BURLINGTON DEVELOPMENT REVIEW BOARD

Tuesday July 5, 2016

To: Development Review Board
From: Mary O'Neil, AICP, Principal Planner
Date: July 5, 2016
RE: ZP16-1262CA, 6 Proctor Place

Exterior Light

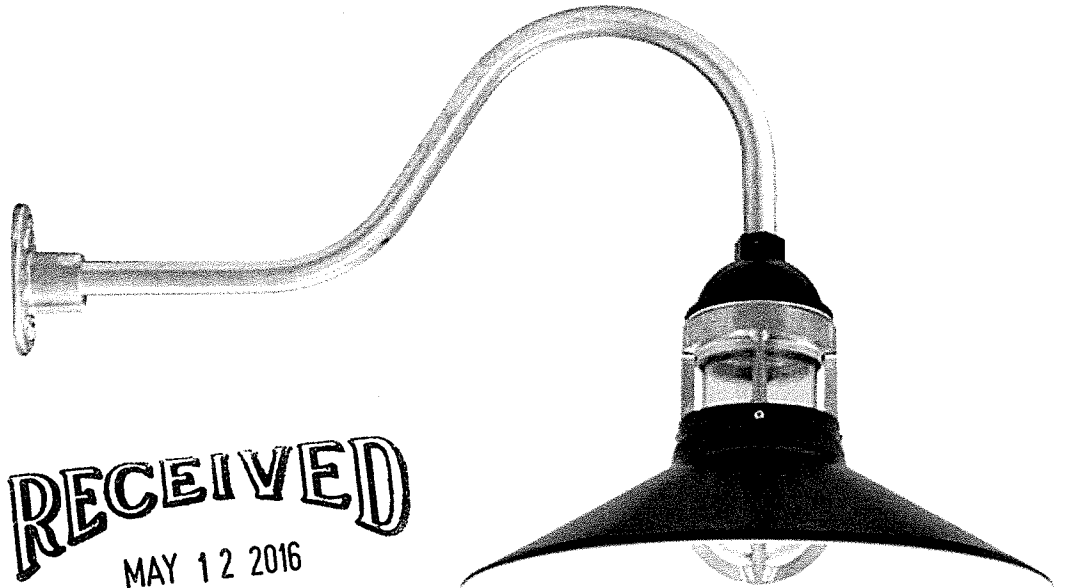
Plans include a residential scale full cut-off exterior light fixture. **Affirmative finding.**

SOUTH ELEVATION

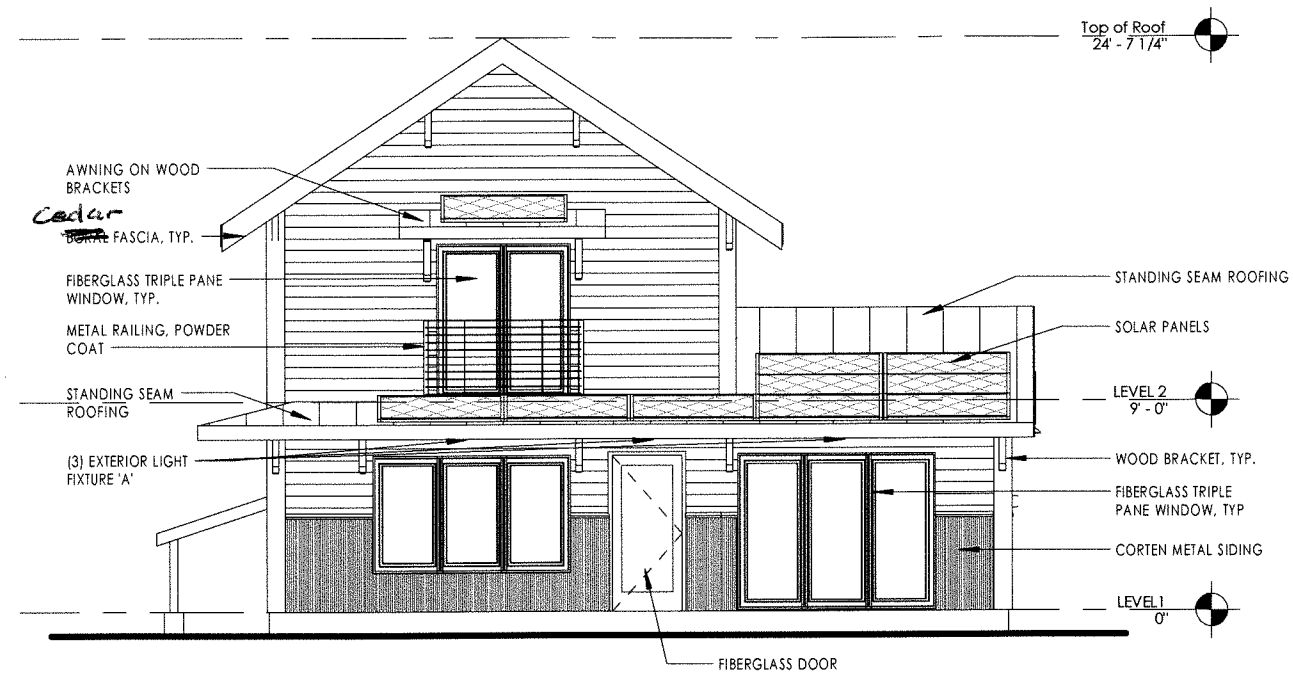
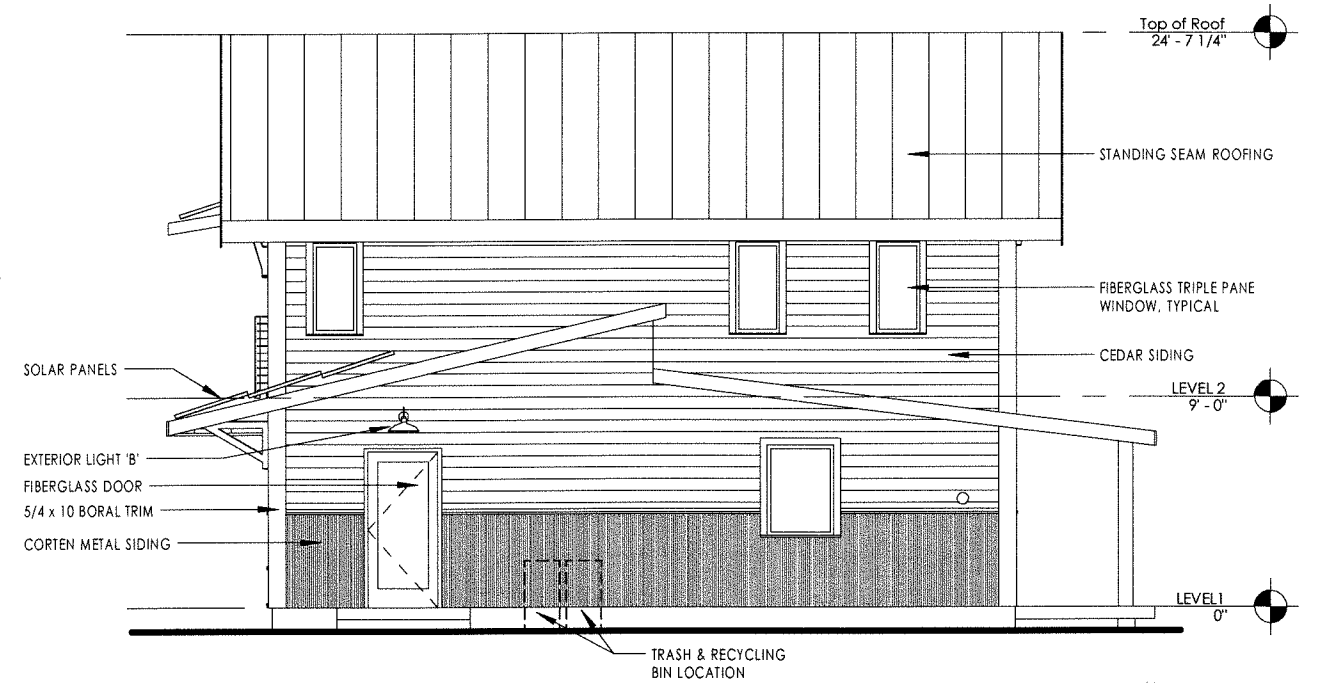
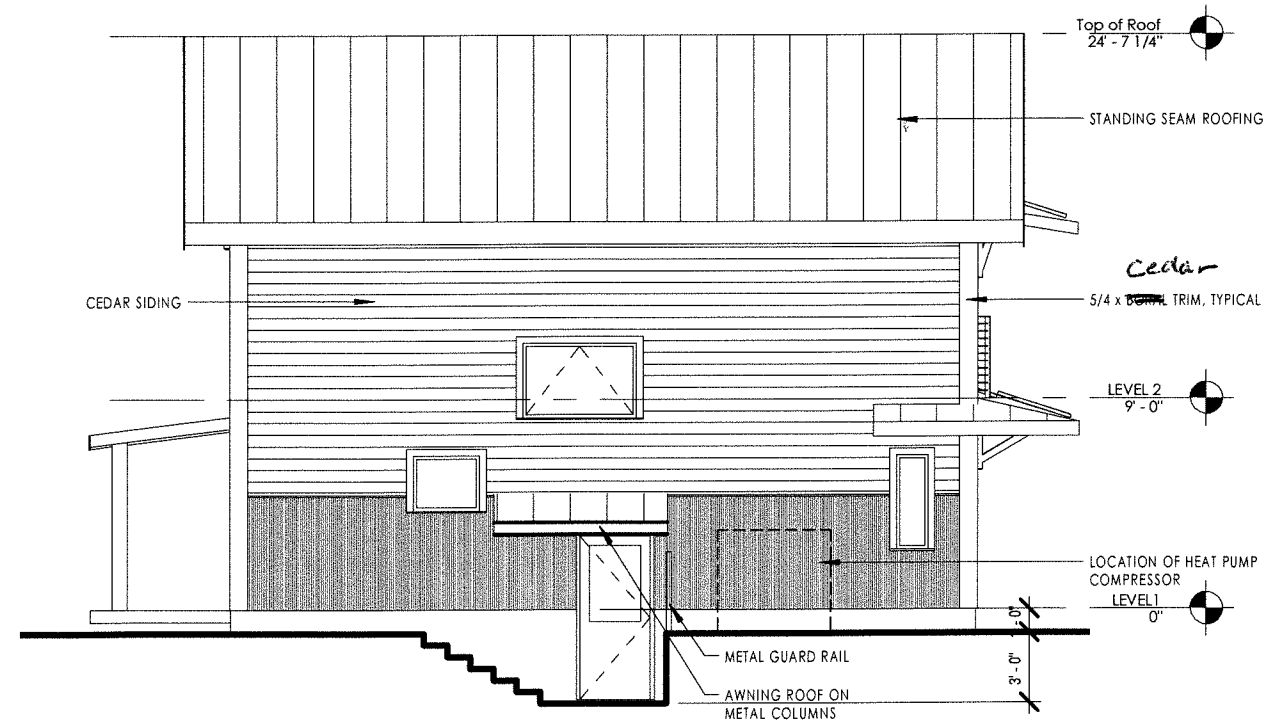
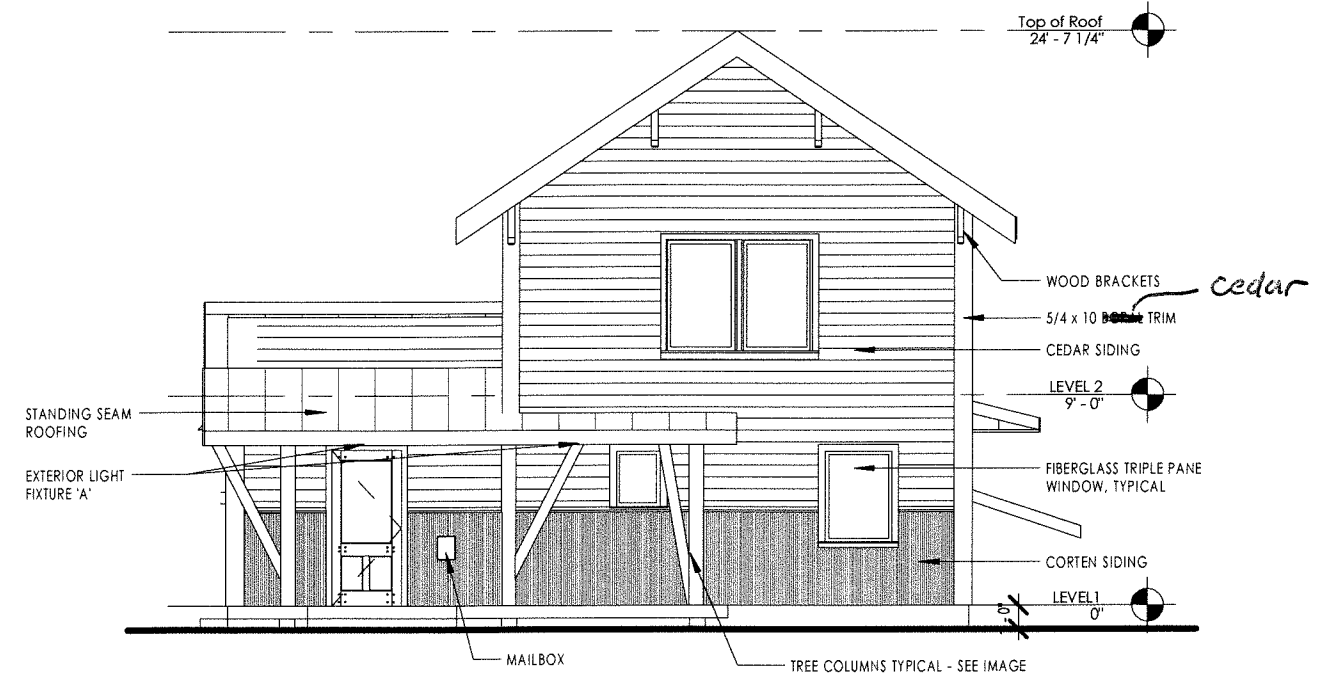
(p) *Integrate infrastructure into the design*
New utilities will be undergrounded. The location of the heat pump is identified on the west elevation; a mailbox is adjacent to the front door. The location of utility connections is not visible on plans and should be. The trash/recycling location is contradictory to the plan, as this area is identified as parking. A different location; perhaps in the walk-out cellar, should be identified.
Affirmative finding as conditioned.

A gable roof plan is proposed, consistent with the existing garage and common to the companion house and other residences within the immediate neighborhood.
The designer may wish to consider the likely event of snowslide off the westerly roof, which may render the exterior basement stairs inaccessible and have a negative impact on the condensing unit. **Affirmative finding** for roof style.

The broadest expanse of glazing is located on the south elevation (rear), which will provide the most benefit of passive solar gain. Windows are distributed around the structure, aligned more vertically than horizontally as required by this standard. Additional windows, especially around the entrance door would be a welcoming feature, as would greater consideration to the “balance” and arrangement across the primary façade.

5. An **Erosion Prevention and Sediment Control Plan** must be approved in writing by the City Stormwater staff.
6. A **landscaping plan** shall be required for review and approval by staff **prior to release of the zoning permit**. The plan shall include relocation of the trash/recycling containers to avoid conflict with the parking area and to minimize visibility; screening for the condensing unit, and any other landscaping or fencing proposed for the property.
